Traffic Engineering Division

November 14, 2005

SUBJECT: **700 University Avenue – Rezoning – C2 to PUD (PUD-SIP) – Build 12 Story building Mix Use, 130,000 Sq. Ft. Retail, 73,000 Sq. Ft. Office, 91,000 Sq. Ft. Health Center, 60,500 Sq. Ft. Activity Center & 430 Dwelling Units**

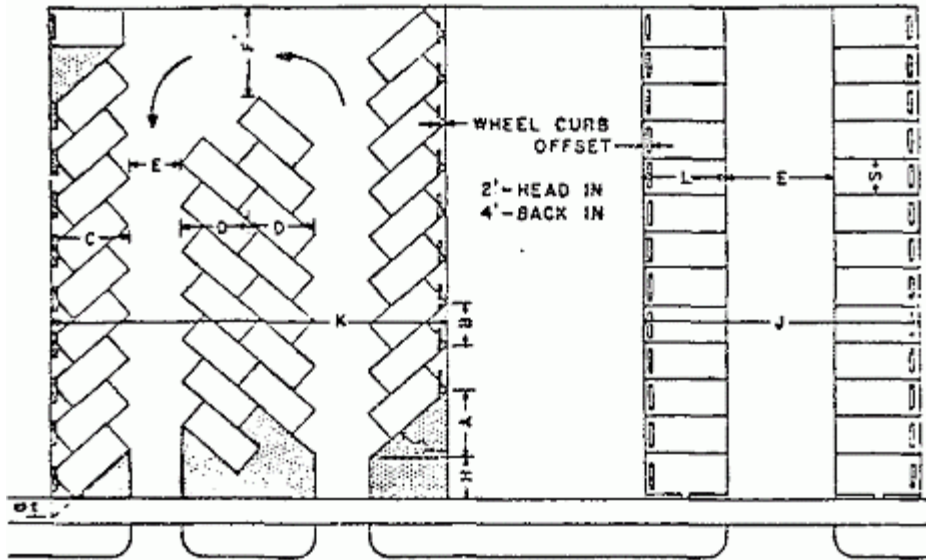
10. City of Madison radio systems are microwave directional line of sight to remote towers citywide. The building elevation will need to be review by Traffic Engineer to accommodate the microwave sight and building. The applicant shall submit grade and elevations plans if the building exceeds four stories prior to sign-off to be reviewed and approved by Keith Lippert, (266-4767) Traffic Engineering Shop, 1120 Sayle Street. The applicant shall return one signed approved building elevation copy to the City of Madison Traffic Engineering office with final plans for sign off.
